I-5507 - Interstate 485 improvements from I-77 to US 74 (Independence Blvd)

Subject: Request for Modification for Section 404 Regional General Permit No. 201902350 and Section 401 Water Quality Certification for the Interstate 485 (I-485) improvements from I-77 to US 74 (Independence Boulevard), Mecklenburg County, Division 10, TIP I-5507. Debit \$570.00 from WBS 43609.3.2.

Permit Impact Site Modifications (shown in revised permit drawings):

PROJECT REFERENCE NO.		SHEET NO.	
I-5507		24	
RW SHEET NO.			
ROADWAY DESIGN ENGINEER		HYDRAULICS ENGINEER

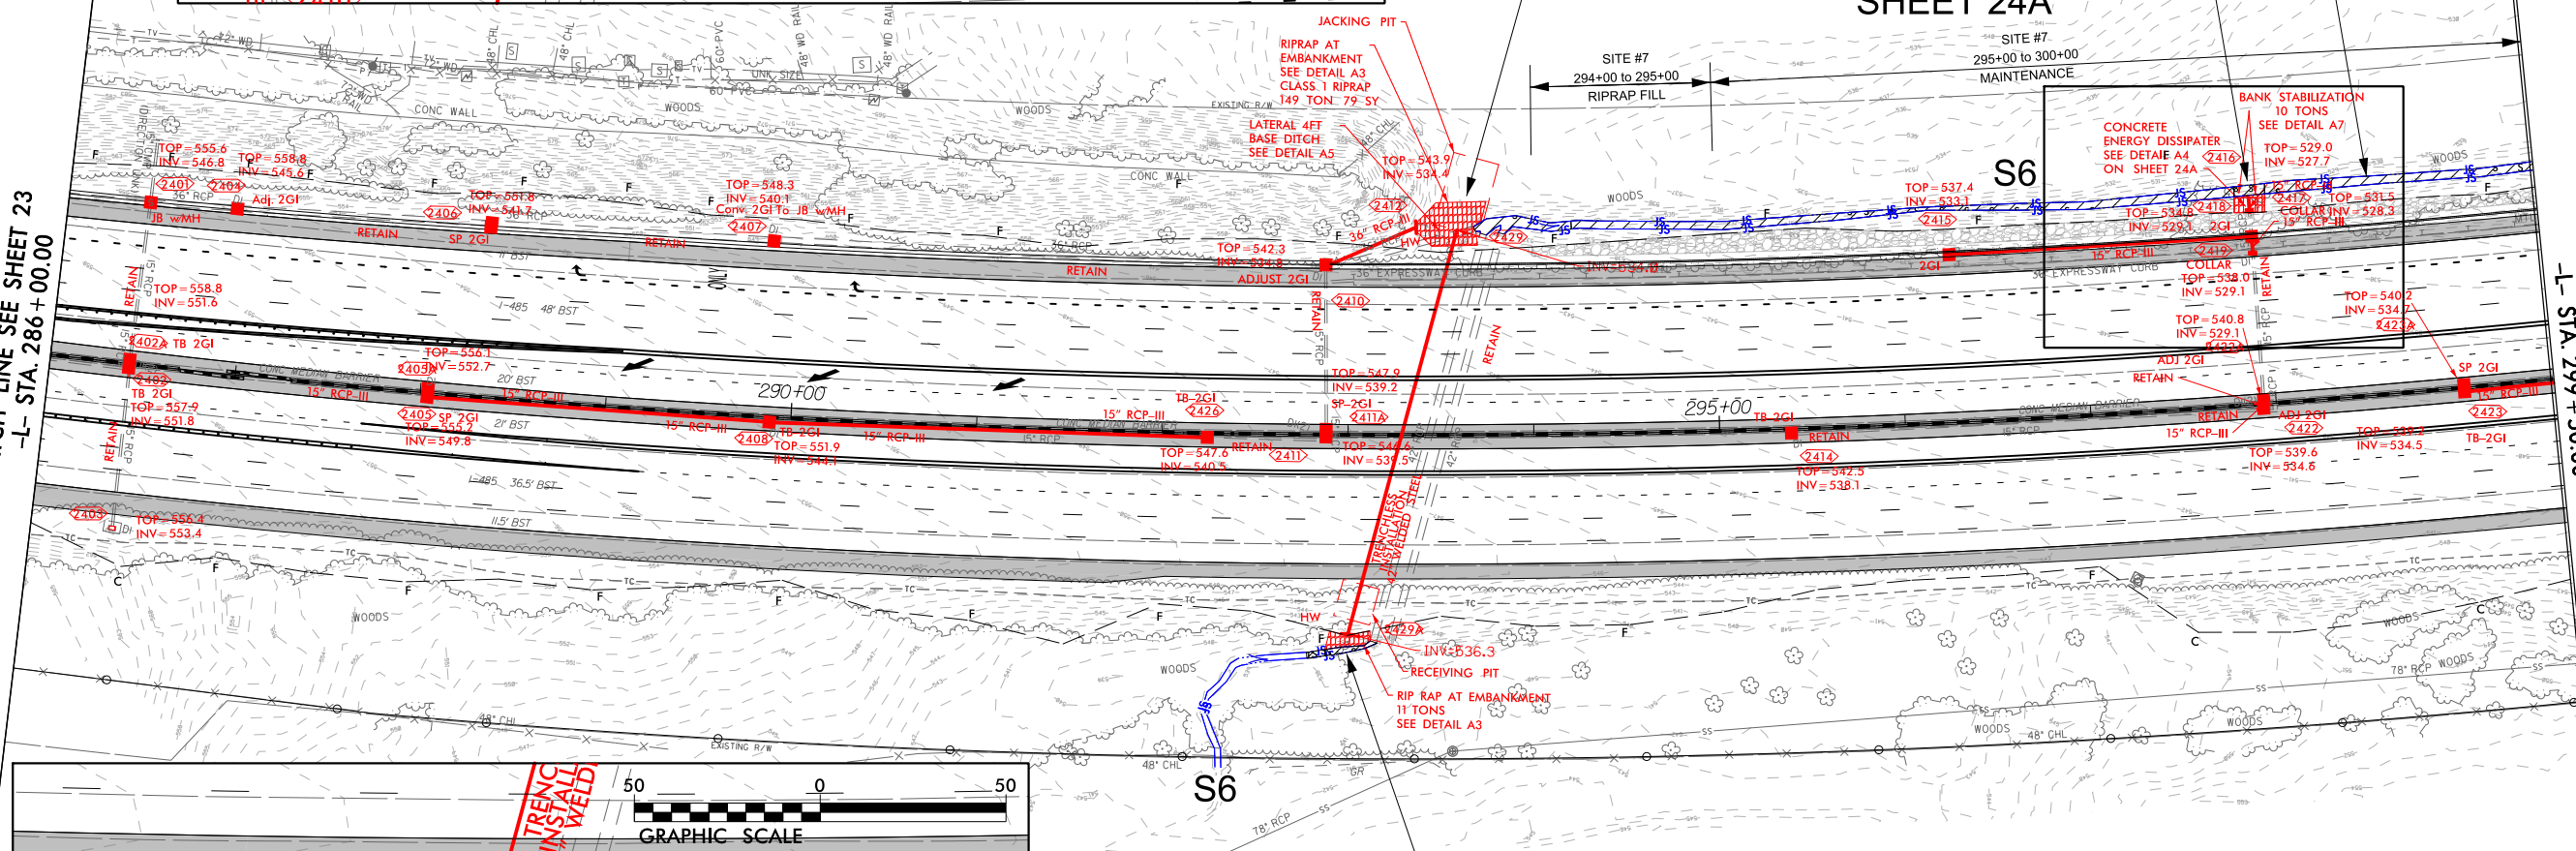
Site 7

The original approved impacts at Site 7 included 680 linear feet (0.07 acre) of temporary surface water impacts in Stream S6 associated with the installation of rock plating between Stations 294+00 and 301+00. The original design did not propose extending the rock plating to below the ordinary high water mark. Through on-site coordination with and approval by Donna Hood of NCDWR during construction, permanent riprap stream bed stabilization was determined to be needed between Stations 294+00 and 295+00. In addition, through on-site coordination with NCDWR the rock plating was extended to the toe of slope between Stations 294+00 and 302+00 to prevent future scour that might jeopardize the slope and shoulder of the roadway. Following clearing of vegetation it was determined that the stream banks between Station 295+00 and Station 300+00 had been previously lined with riprap; therefore, the rock plating in these locations was determined to be a maintenance activity consisting of reconditioning the slopes. Based on these field changes, the proposed impacts at Site 7 include the following:

- Station 294+00 to Station 295+00: 100 feet of riprap fill impacts
- Station 295+00 to Station 300+00: 500 feet of stream bank maintenance
- Station 300+00 to Station 302+00: 200 feet of stream bank stabilization

Site 8

The original design at Site 8, which included installation of a concrete energy dissipator at Station 298+00, has not changed. However, the stream bank stabilization identified in the prior permit approval is now accounted for in the length of stream bank maintenance for Site 7. Permanent impact for Site 8 now consists of 7 linear feet of stream bed impacts for the energy dissipator.

295+00 to 300+00
MAINTENANCE

IMPACTS IN SURFACE WATER
CONCRETE
ENERGY DISSIPATER
SEE DETAIL A4
ON SHEET 24A

BANK STABILIZATION
10 TONS
SEE DETAIL A7

PROJECT REFERENCE NO.		SHEET NO.
I-5507		49
RW SHEET NO.		
ROADWAY DESIGN ENGINEER		HYDRAULICS ENGINEER

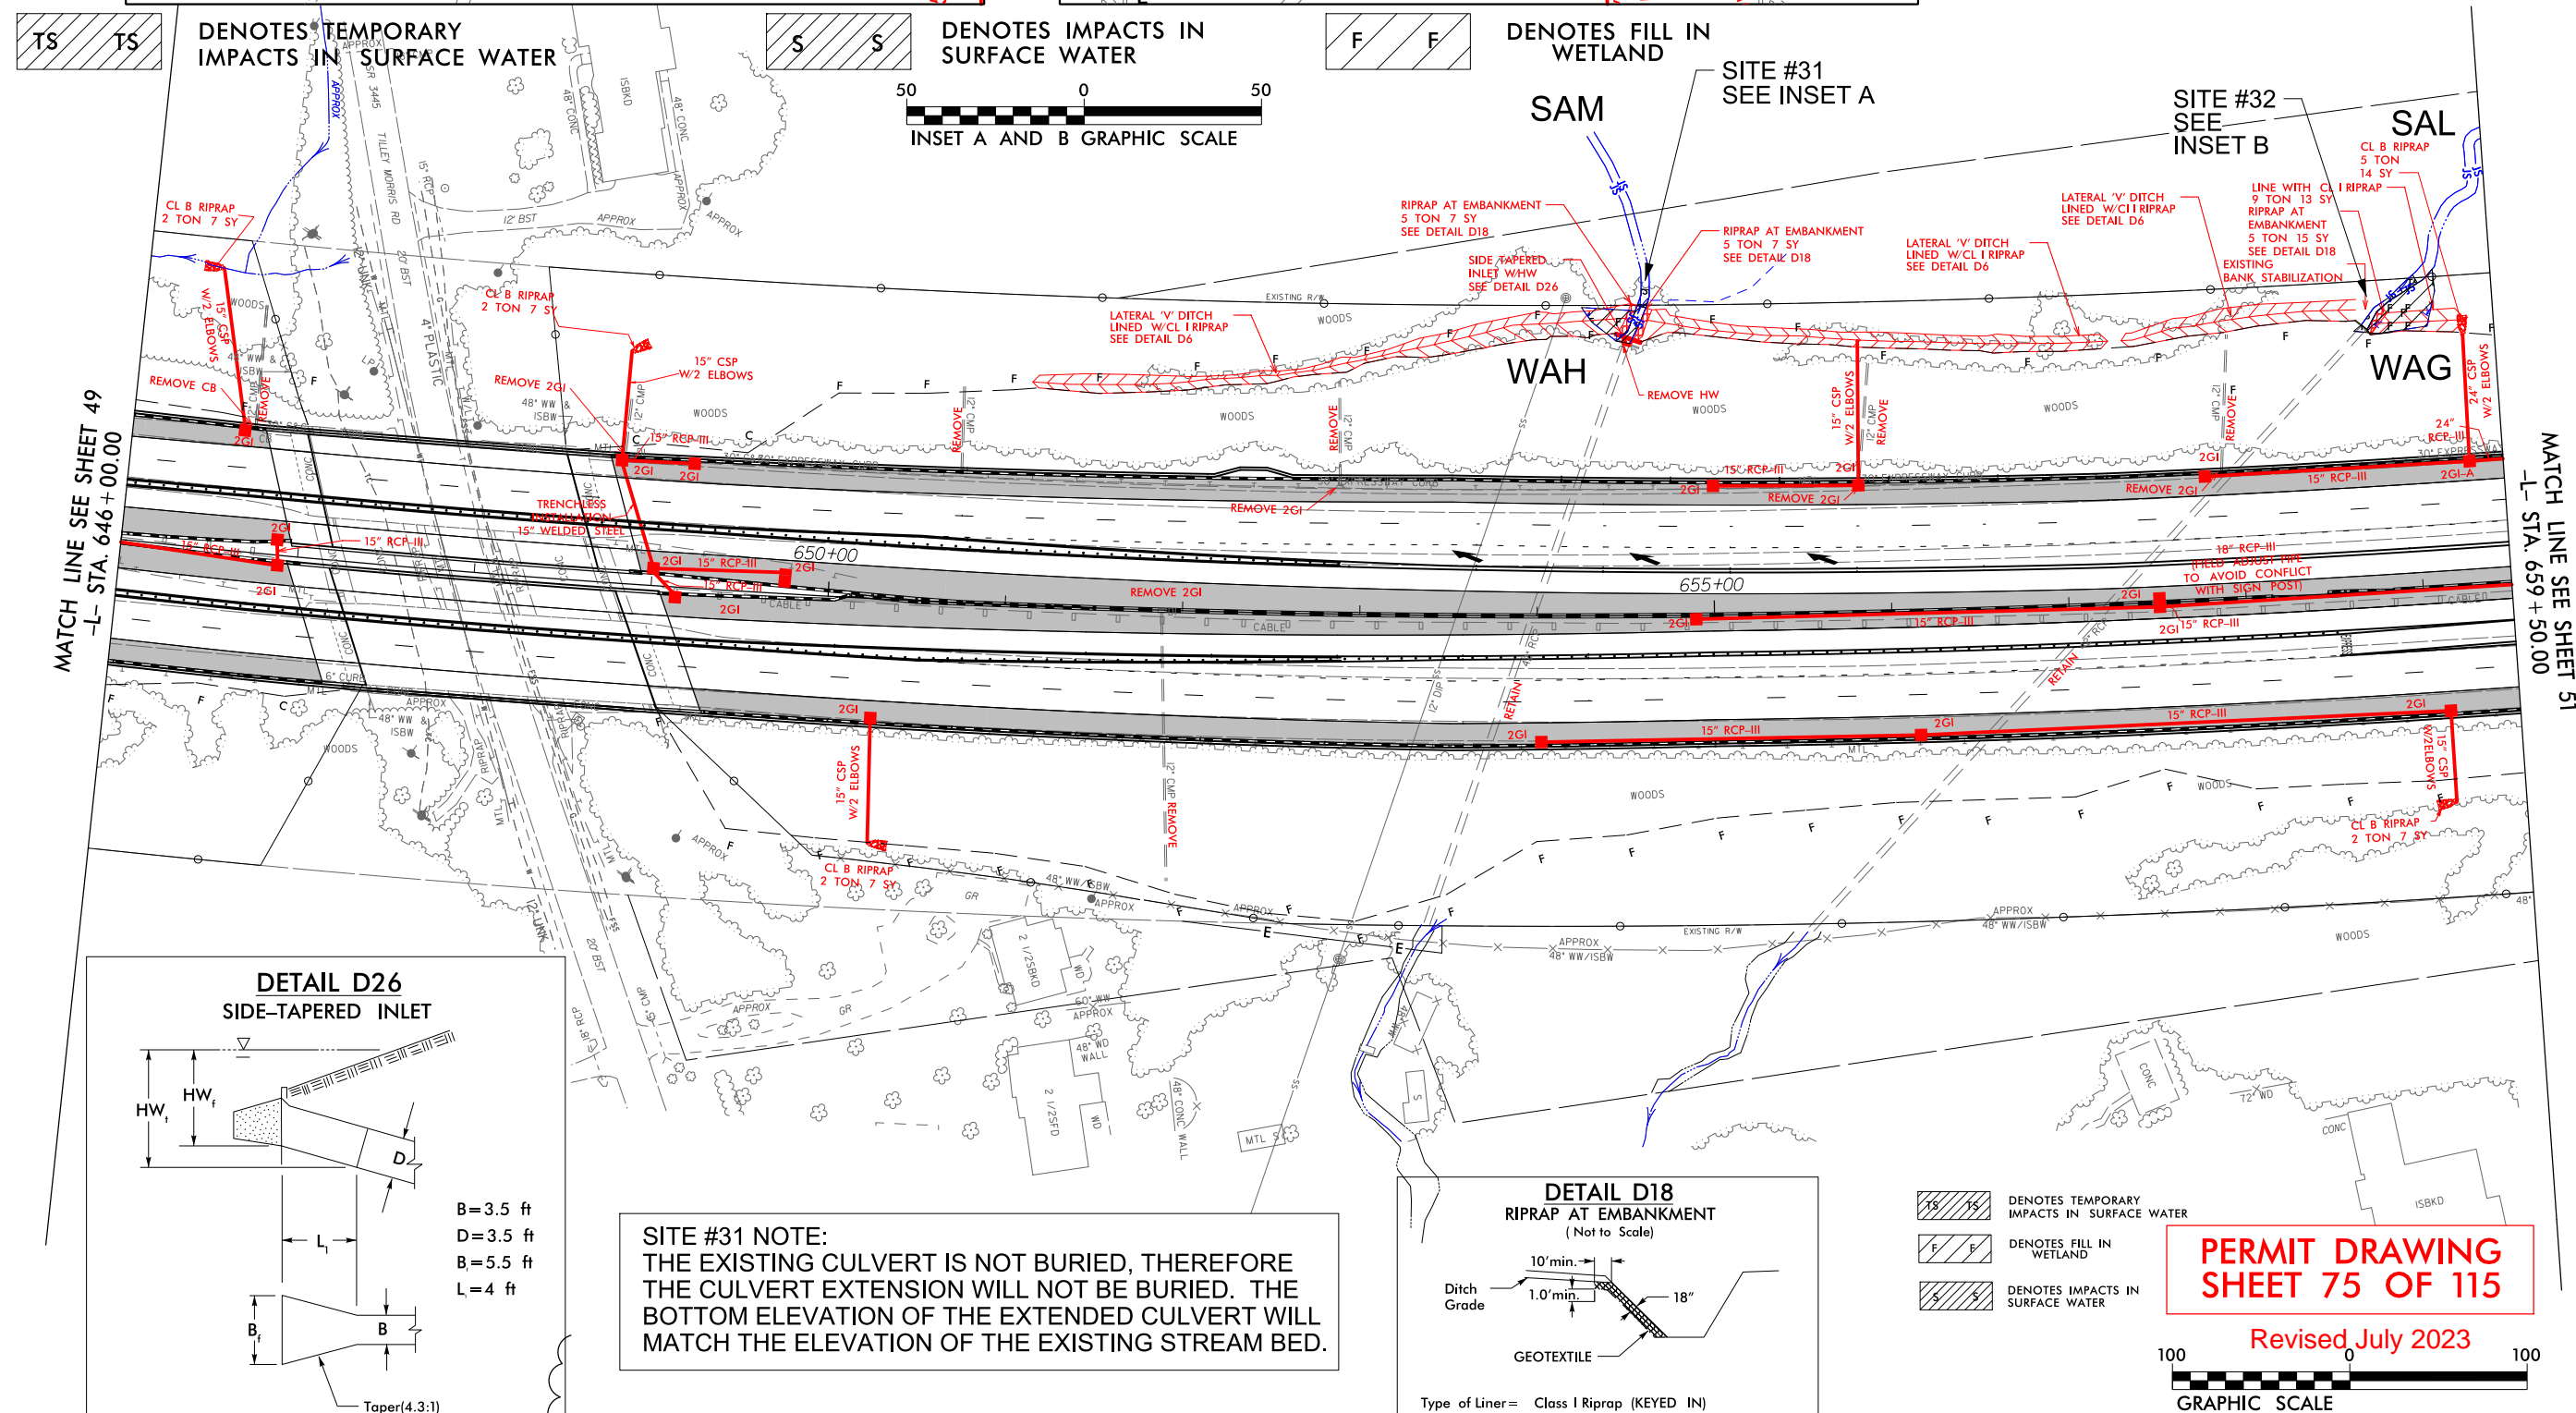
Site 30

The original approved impacts at Site 30 included 33 linear feet of temporary impact to Stream SAN associated with installation of a side tapered inlet and headwall at the end of an existing 36" reinforced concrete pipe (RCP) culvert. The original design at this location included a 4-foot extension of the existing

36" RCP, which was inadvertently omitted from the permit. The revised impacts at Site 30 include 13 linear feet of permanent stream impacts resulting from the culvert extension, side tapered inlet, and headwall. Temporary impacts would be 20 linear feet.

PROJECT REFERENCE NO.		SHEET NO.
I-5507		57
RW SHEET NO.		
ROADWAY DESIGN ENGINEER		HYDRAULICS ENGINEER

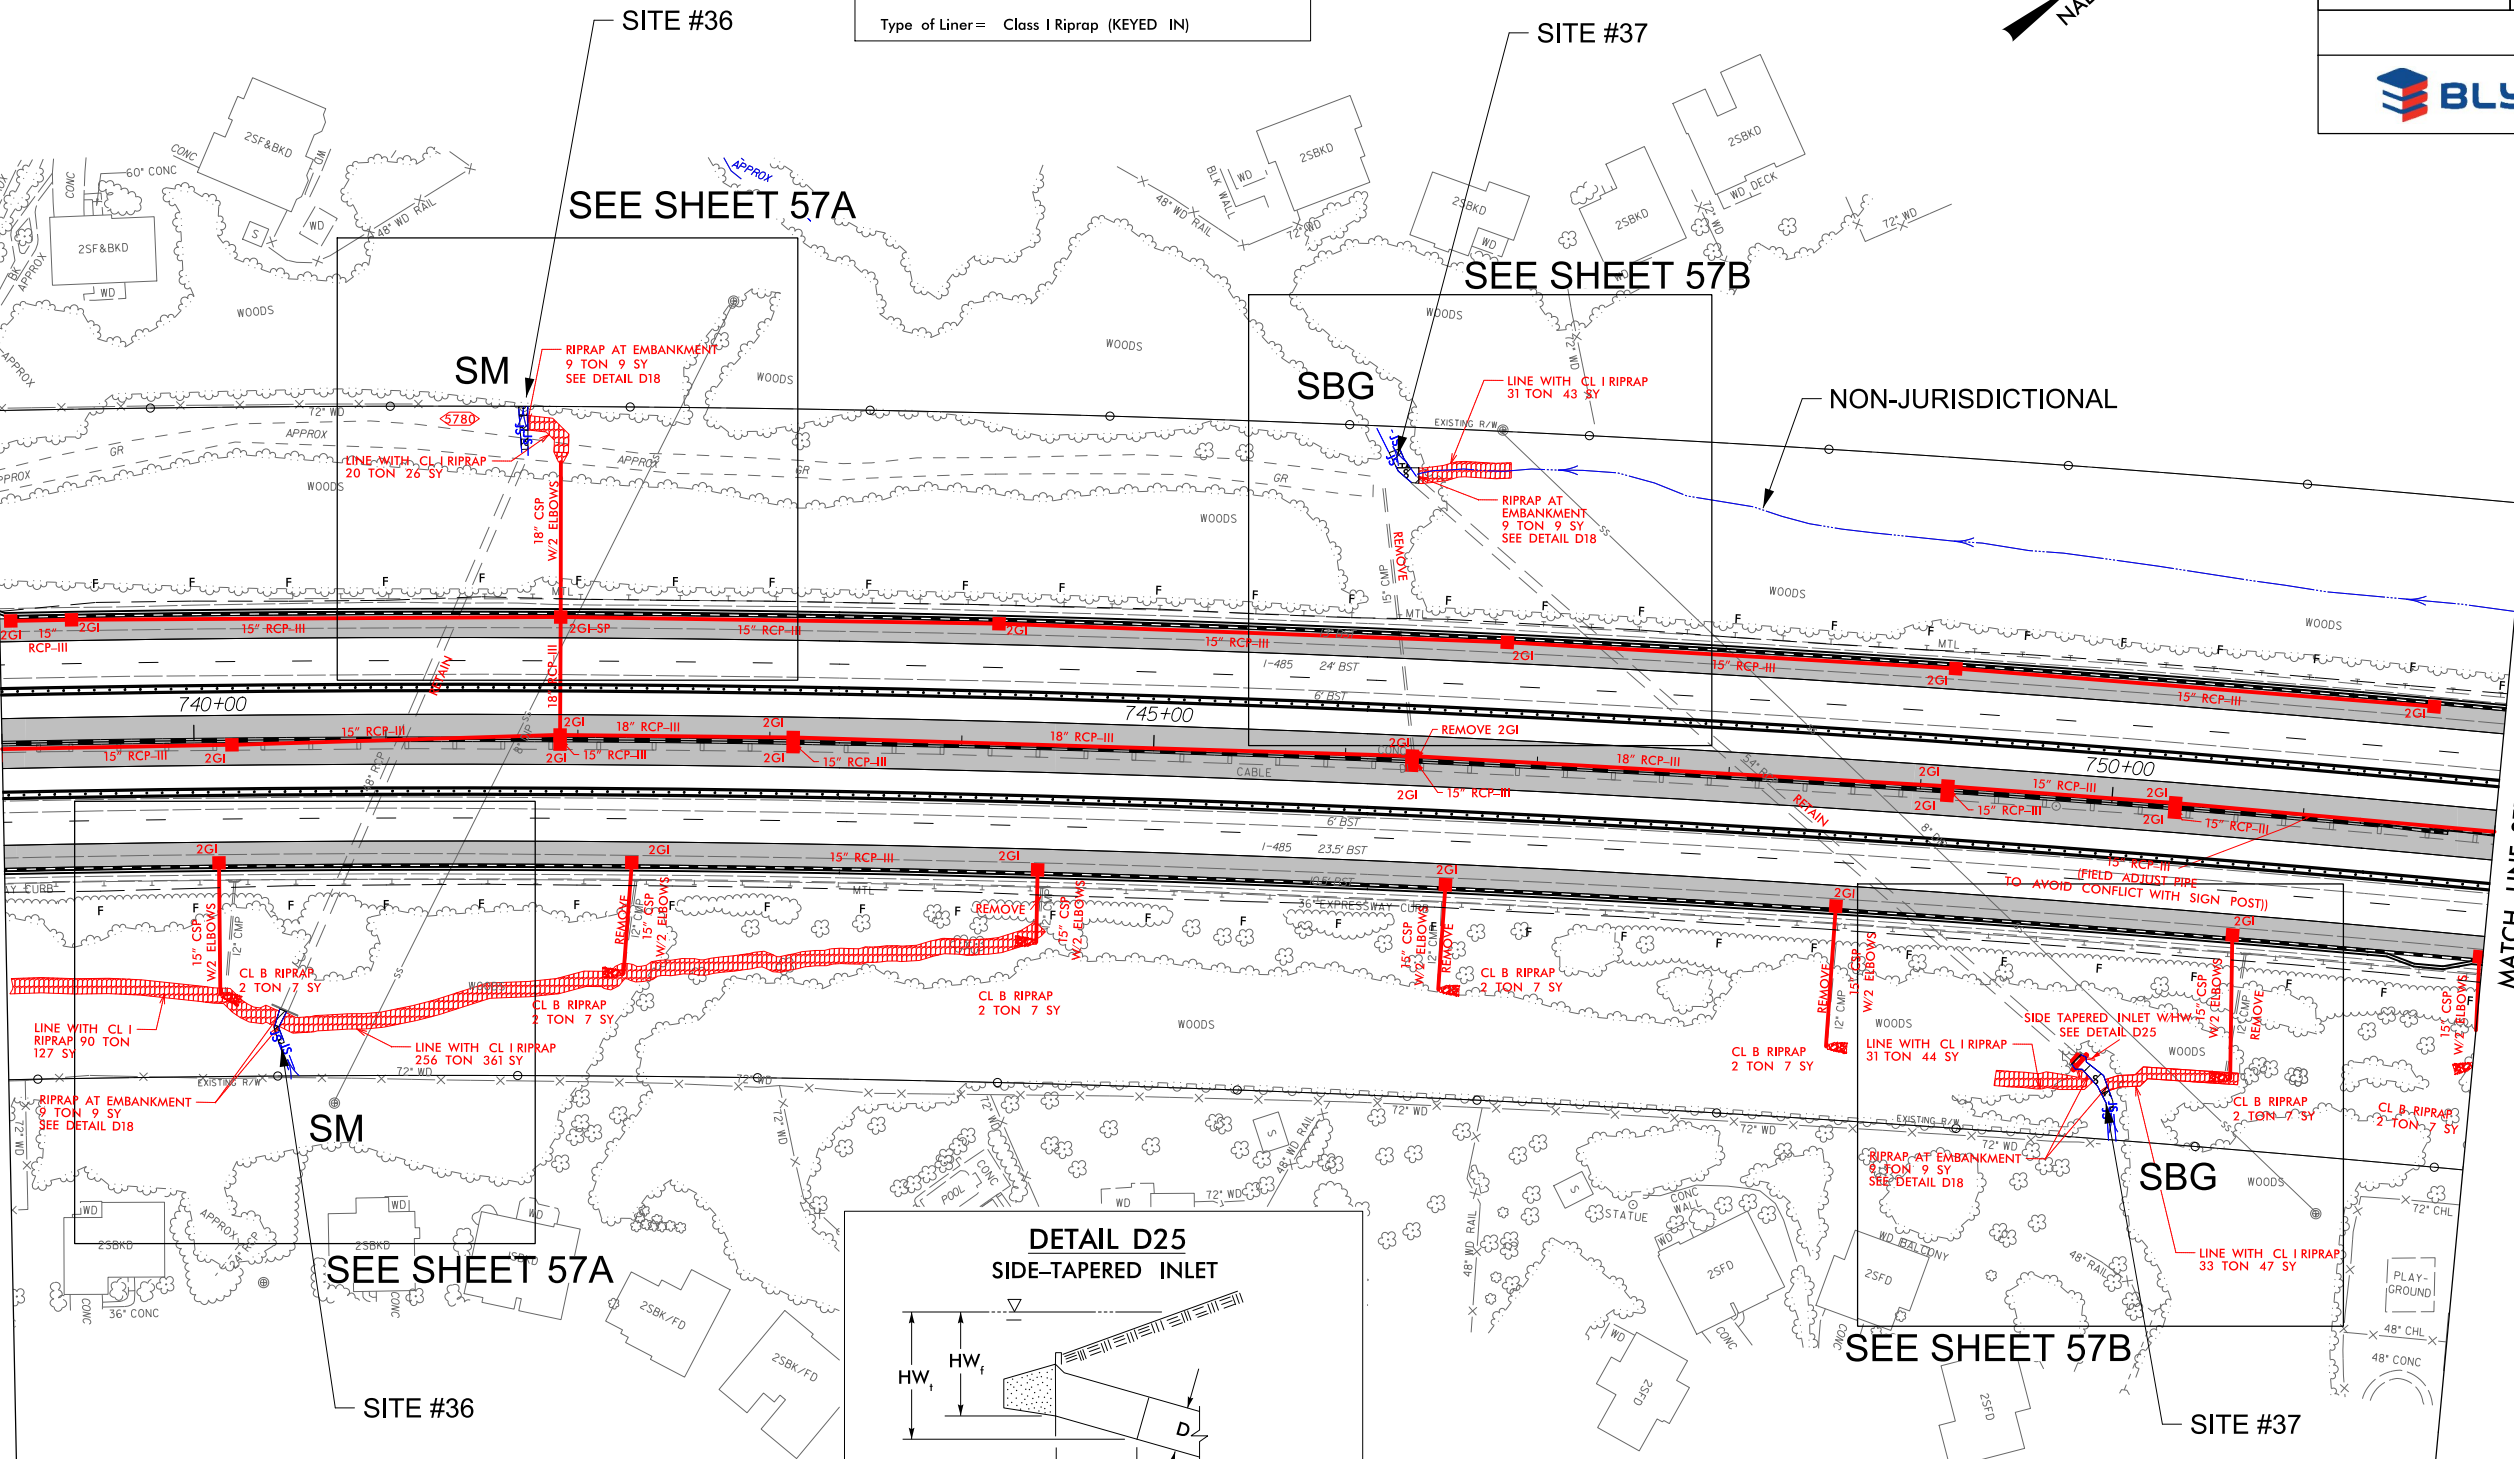
Site 37

The original approved impacts at Site 37 included 35 linear feet of stream bank stabilization and 20 linear feet of temporary stream impacts associated with lateral ditch outfall tie-ins. The design has been revised near Station 749+80 to include a 4 ft extension to the existing 54" RCP at this site. The revised impacts at Site 37 include 4 linear feet of permanent stream impacts associated with the RCP extension, 31 linear feet of stream bank stabilization, and 20 linear feet of temporary stream impacts.
